Notice of Decision

Conditional Use Review

South Albany High School Addition and Renovation

CU-02-18

SITE PLAN
SOUTH ALBANY HIGH SCHOOL (SAHS)

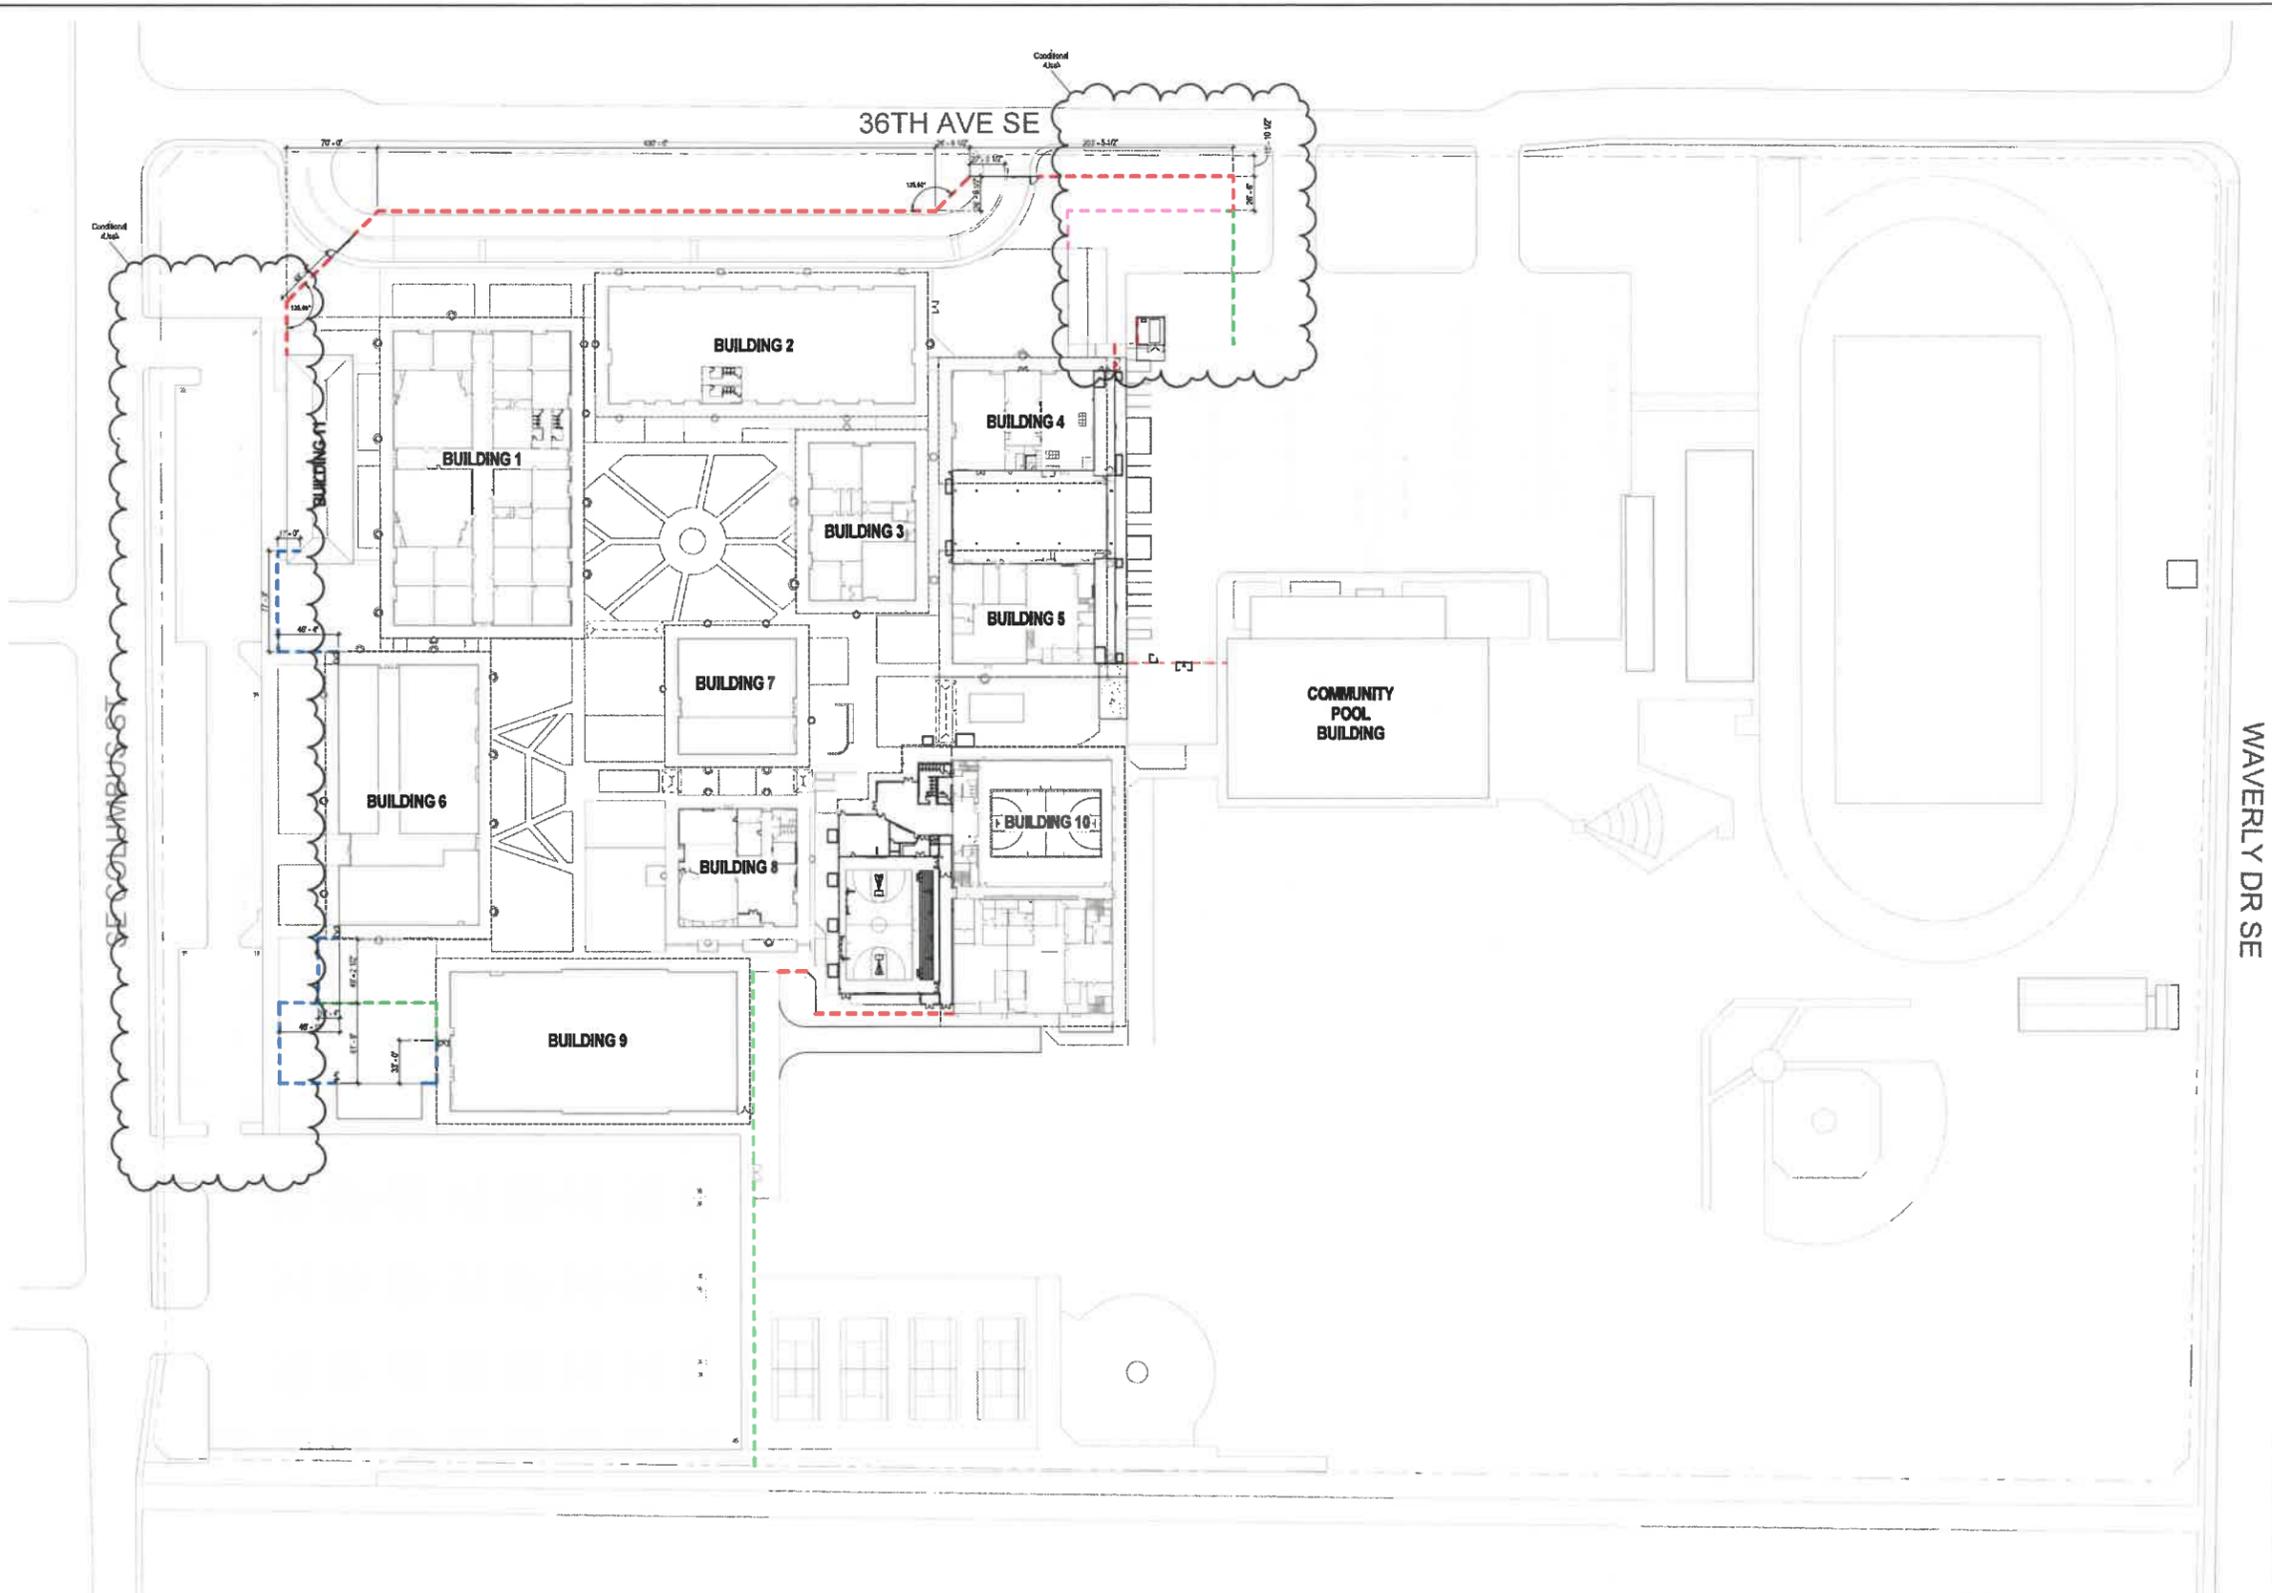
- **Example: Buildings 4 and 5, the covered area and the new additions become one building. Show how they meet the allowable area for one building. These buildings are also near Building 3. Show the resulting building does not violate the space used to create Buildings 2 and 3.**
- **The new gym must be shown to not violate the space used for Building 8.**
- **Exterior covered walkways constructed as part of the building will be considered usable space of the building area. Other walkways and canopies may use OSSC 3104.**
